1008 Springvale Road Great Falls, Virginia

RPA ENCROACHMENT EXCEPTION #7996-WRPA-002 & WATER QUALITY IMPACT ASSESSMENT #7996-WQ-001 SECTION 118-6-9, GENERAL RESOURCE PROTECTION AREA ENCROACHMENT REQUEST

APPLICANT REPRESENTED BY TNT ENVIRONMENTAL, INC.

View of the existing sport court facing west

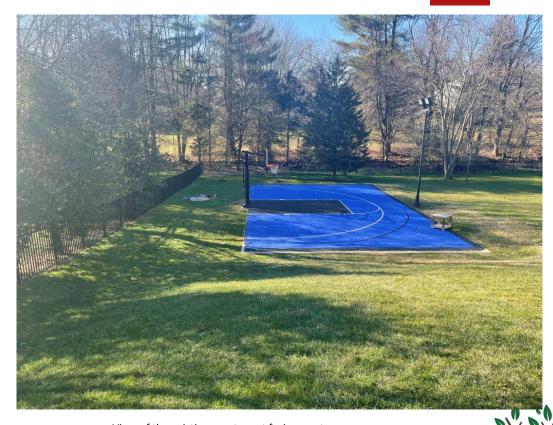
- Staff Comment: The sport court could be located outside the RPA.
 - > Contrary to what's shown in Attachment C5-3A, there are no viable alternative locations for the sport court outside the RPA.
 - > The two locations shown proximate to the existing well do not adhere to the state mandated setback requirements (Section 12 VAC 5-630-380).
 - > The existing slope of the front yard is not conducive do locating the sport court in this location. See photograph to the right.
